County and City highway/ traffic staff are subverting the Master Plan (map excerpt, right) to add future traffic lanes. This Plan states: "shoulder or path facilities [gray] can serve ... for occasional pedestrian use." [Page 93, copied with photo of walker using a dirt path.]

The BAC requests the Council to support a pedestrian, mostly-parallel, route along San Tomas, between Monroe ("Creek Trail") and Benton, by opening five fences and using paths, initially dirt but eventually paved, in addition to existing nearby sidewalks. Bicycling should also be allowed on portions of this route where:

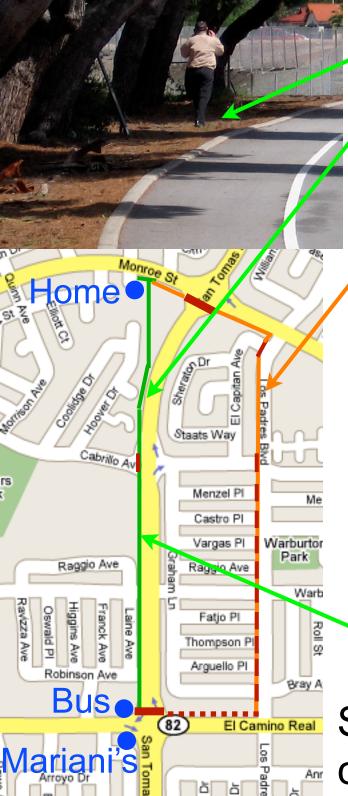
Path and shoulder here for the entire block, but staff opposes repeal! This increases accident risk shown by the number of crossings:

Staff ignored the greatest danger: crossings.

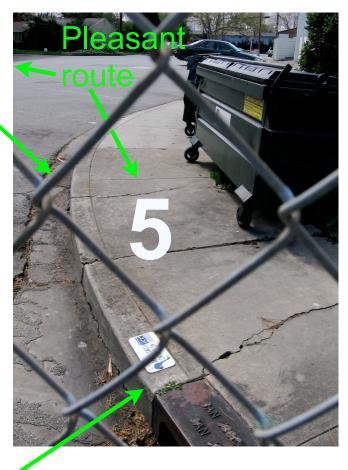
El Camino intersection (NW): **Trim shrubs** as was done for other side, until reaching the opening in the fence. This is *already required* by the Master Plan [page 93]. Curb to fence is 12 feet (see tape).

Shoulder line starts beyond intersection. Bicyclists ride near line. This is a standard bike lane, 5 feet wide.

If there's no sidewalk, then dirt path is *required* at "intersection areas".

Gutter pan (or equivalent space) is where people walk where there's no path or sidewalk, and is avoided by bicyclists.

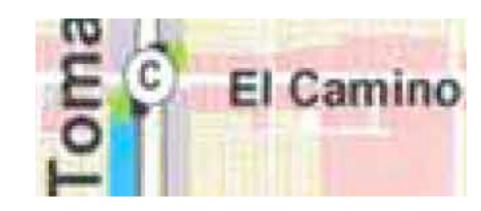
- a) it goes through fences.
- b) it's along San Tomas, to prevent needless crossings of San Tomas. [continued]
